SUBJECT: NINE MILE POINT NUCLEAR STATION UNITS 1 AND 2 – STAFF
ASSESSMENT OF RESPONSE TO 10 CFR 50.54(f) INFORMATION REQUEST
– FLOOD-CAUSING MECHANISM REEVALUATION (TAC NOS. MF1104 AND
MF1105)

STAFF ASSESSMENT BY THE OFFICE OF NUCLEAR REACTOR REGULATION

NINE MILE POINT NUCLEAR STATION UNITS 1 & 2

Figure 3.4-1. Oswego River Watershed basin with the location of the site (red square) and dams (blue dots).

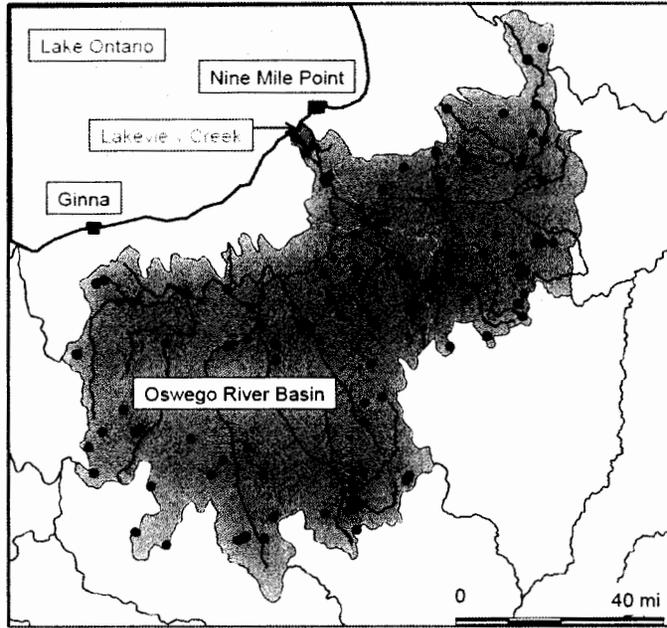
The staff performed a bounding analysis of dam failure flooding in the Oswego River basin. From the 2013 National Inventory of Dams Database maintained by USACE, the staff identified a total of 123 dams within the Oswego River basin (see Figure 3.4-1). Most of the identified dams (about 110 dams) have storage capacity less than 10,000 ac-ft (0.012 km³). The total reservoir volume of these 123 dams is approximately 2,008,600 ac-ft (2.47 km³). The staff conservatively assumed all dams fail simultaneously and discharge water into Lake Ontario without loss. With the surface area of Lake Ontario of 4.7 million acres (19,000 km²), this bounding approach results in a lake level increase of approximately 0.43 ft (0.13 m) which is higher than the licensee's estimate but well below the plant grade and the current design basis flood height.

Figure 4.0-1. Time Series of Water Surface Elevation at Element 8156 Unit 1 – 6-hour PMP (from the FHR Figure 2.1-14).

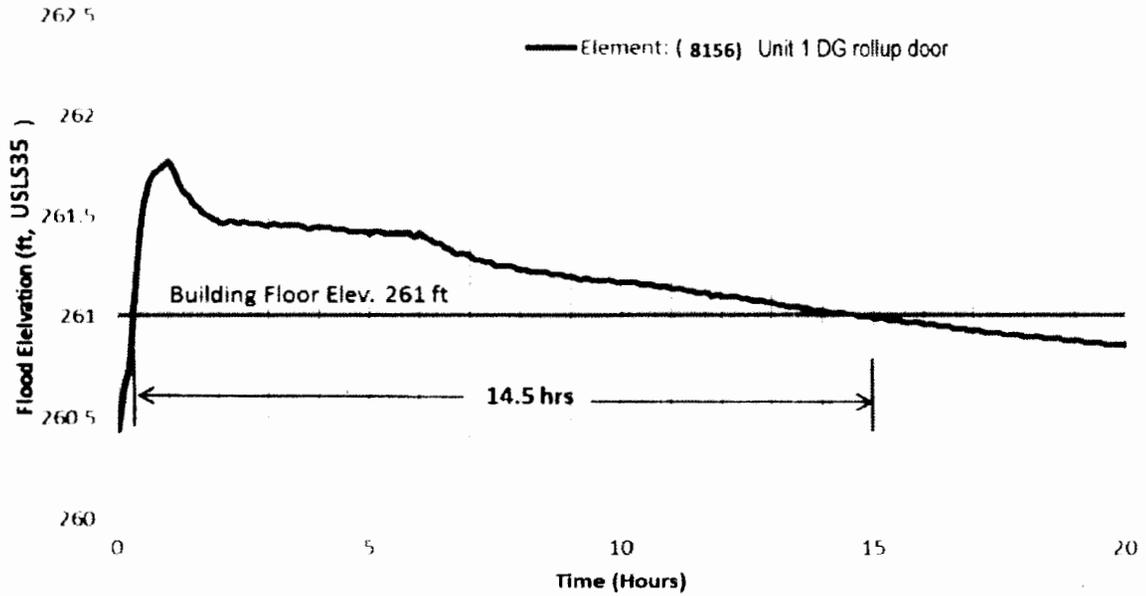
Staff agreed with the licensee's conclusion that the 72-hour PMP event results in the highest water surface elevation and longest period of inundation. However, as described in Section 3.2, the staff noted that PMP events shorter than 72-hour PMP result in (potentially significantly) shorter warning time and likewise results in a flood above the elevation of openings to plant structures. For example, a 6-hour PMP event results in an estimated flood warning time of less than one hour with a flood inundation duration of 14.5 hours above elevation 261 ft (79.55 m) (see Figure 4.0-1). Therefore, the staff determined that, as part of the Integrated Assessment Report, the licensee should evaluate the total plant response for a range of rainfall durations associated with the LIP hazard events (e.g., 1-, 6-, 12-, 24-, 48, 72-hour PMPs) to determine the controlling scenario(s) (see NRC, 2012c). This should include a sensitivity analysis to identify potentially limiting scenarios with respect to plant response when considering flood height, relevant associated effects, and flood event duration parameters. This is Integrated Assessment Action Item No. 2. Flood elevation duration parameters are provided for the 6-hour and 72-hour events in Table 4.0-1.
